Roland VCO 702 DIY corrections .. (for v1 and some for v2 Pcb's)

1. PWM correction of PCB Error 1 – upper side

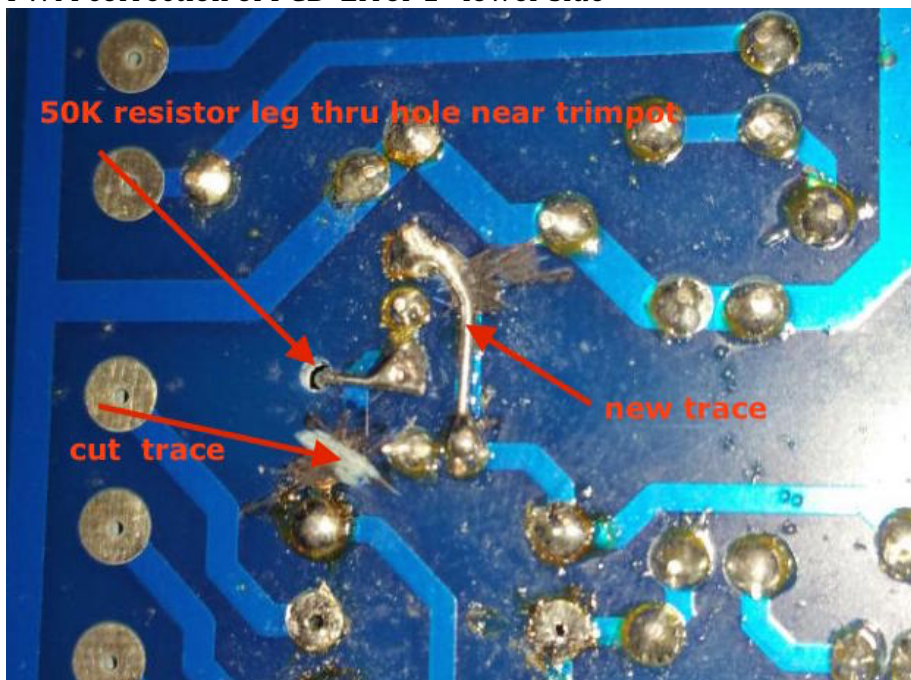
- Remove one side of 50K resistor shown on picture (note 5) and drill a hole near trimpot as shown on picture (note 2).
- Remove one side or 100K resistor from PCB as shown (note 4).
- Add a wire (white one in the picture) and connect removed side of 100K resistor and side of 50K resistor as on picture. (note 1 to note 4).
- Do not populate jumper (note3).

2. PWM correction of PCB Error 1– lower side

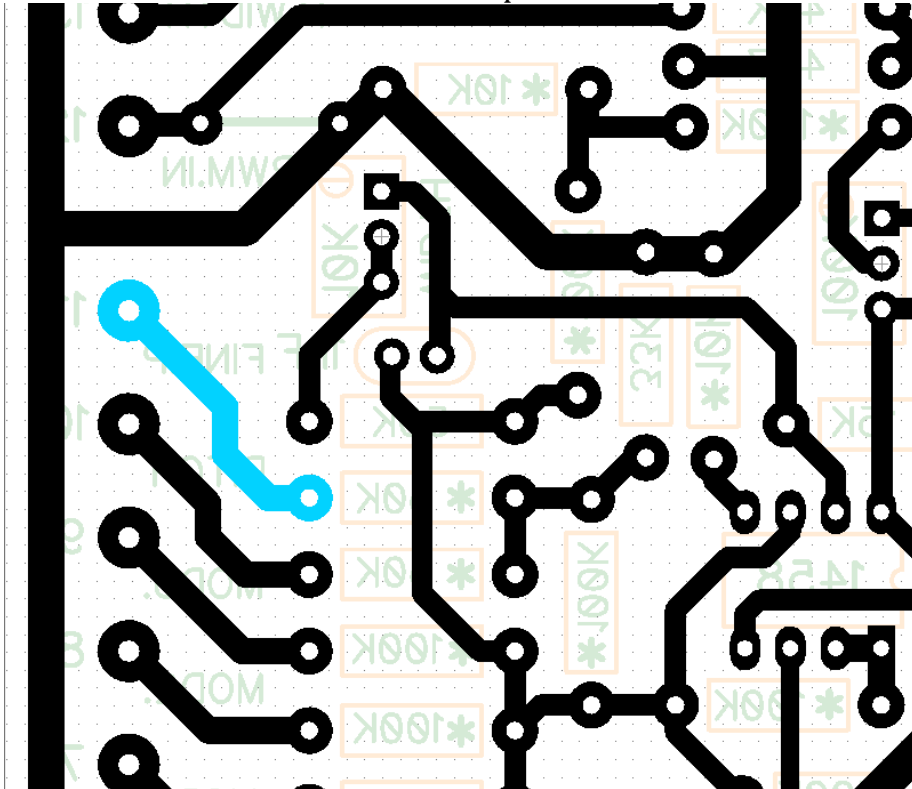
this is how v3 PCB correction of this part looks like !

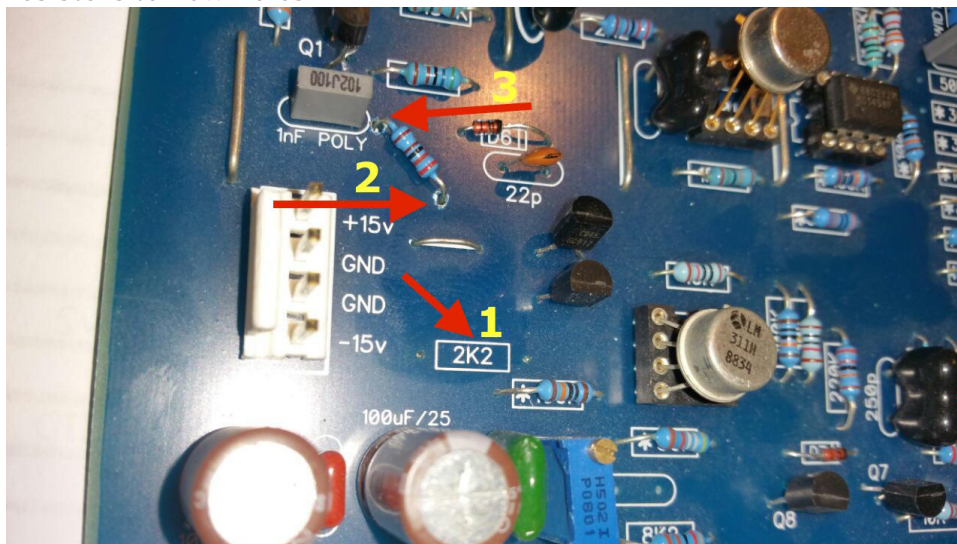
3. Relocating 2k2 resistor on PCB Error 2- upper side
 - Remove 2k2 resistor as shown on picture (note 1)
 - Drill 2 new holes as shown on picture (note 2 and note 3) .. add new resistors to new holes.

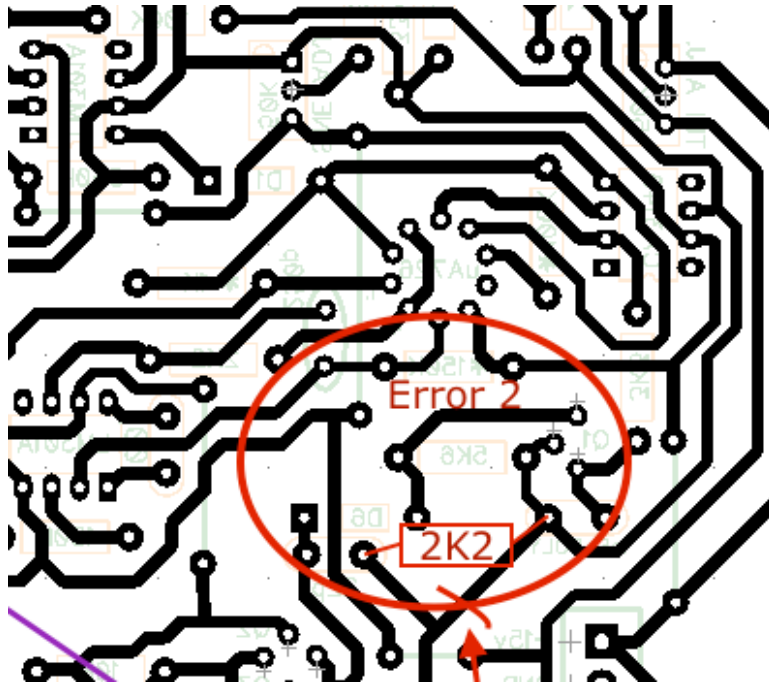
4. Relocating 2k2 resistor on PCB Error 2 - lower side
 - Picture shows where 2k2 relocated resistor should be connected - soldered to PCB .

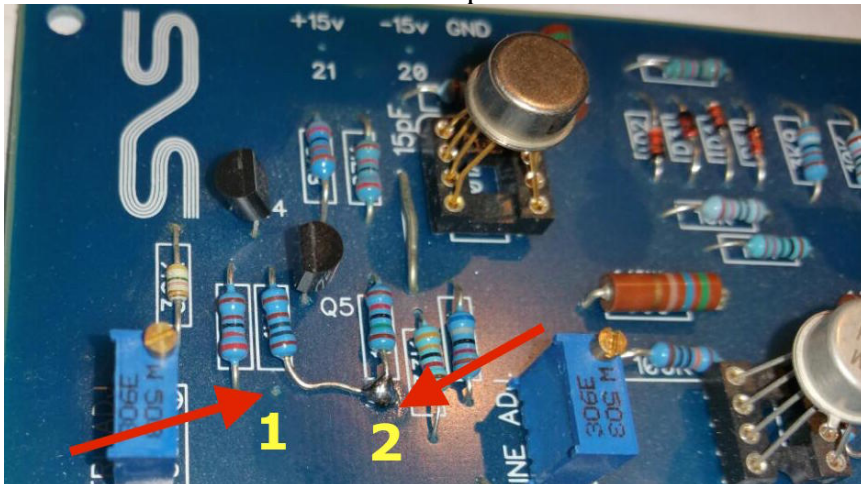
5. Error 3 - only upper side- remove resistor 1K from PCB (note 1) and solder it to 15K resistor near it to pin as shown in note 2.

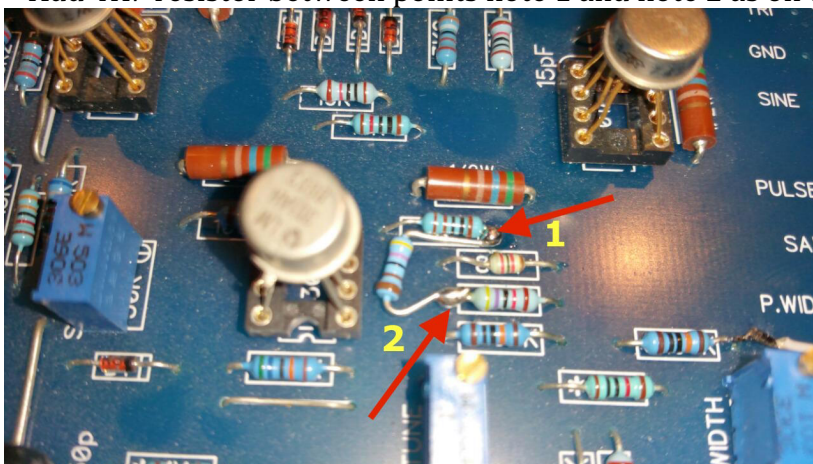
6. Error 4 only upper side:
 - Add 4K7 resistor between points note 1 and note 2 as on the picture.

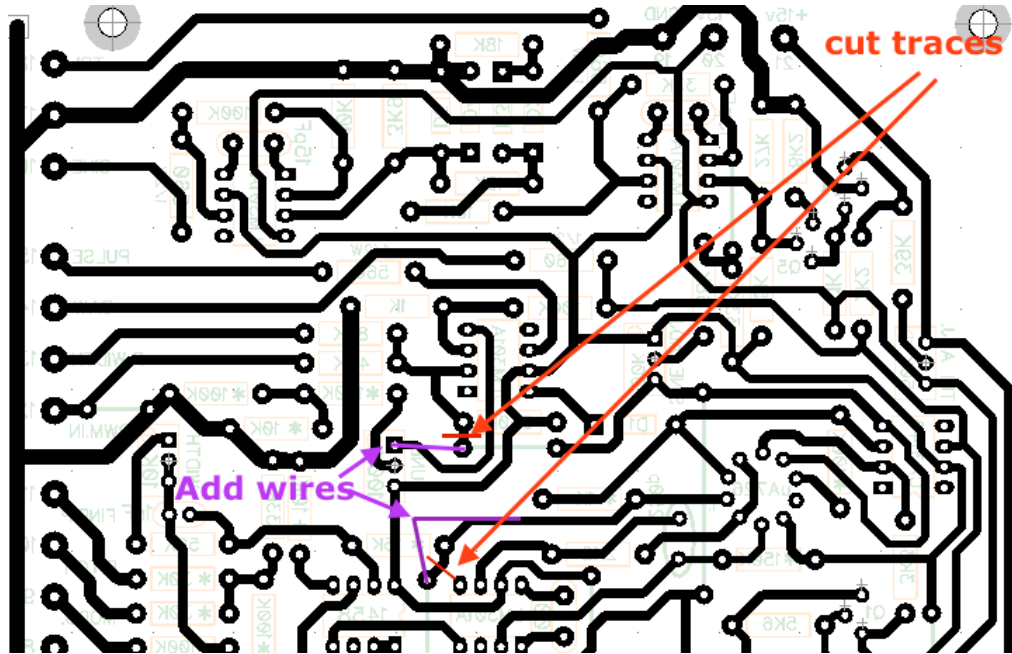
7. Errors 5 and 6 – cut traces and add wires
- both errors are on bottom side
 - purple colored lines show jumpers to add
 - red colored lines show traces to cut!

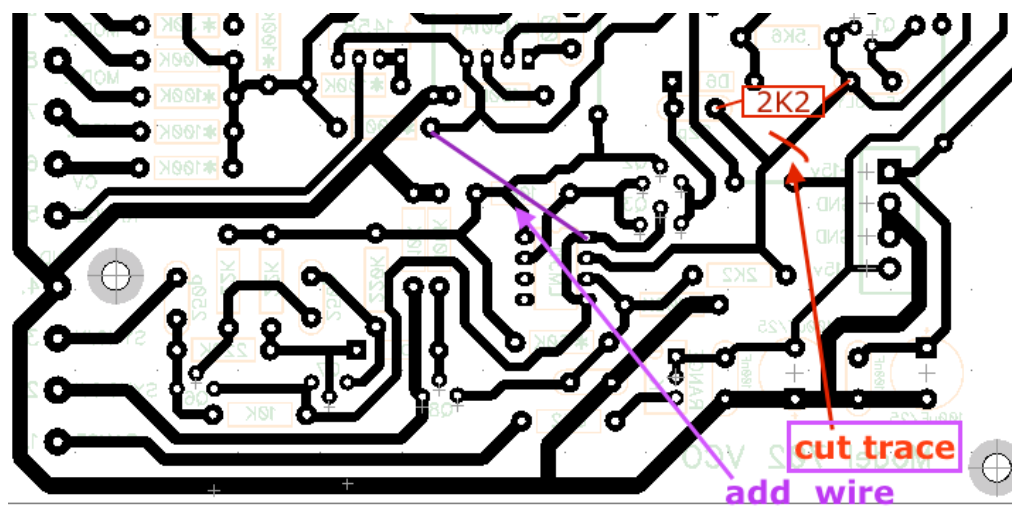
8. Errors 7 and 8 - cut trace and add wire
- both errors are on bottom side
 - purple colored line show jumper to add
 - red colored line show trace to cut!
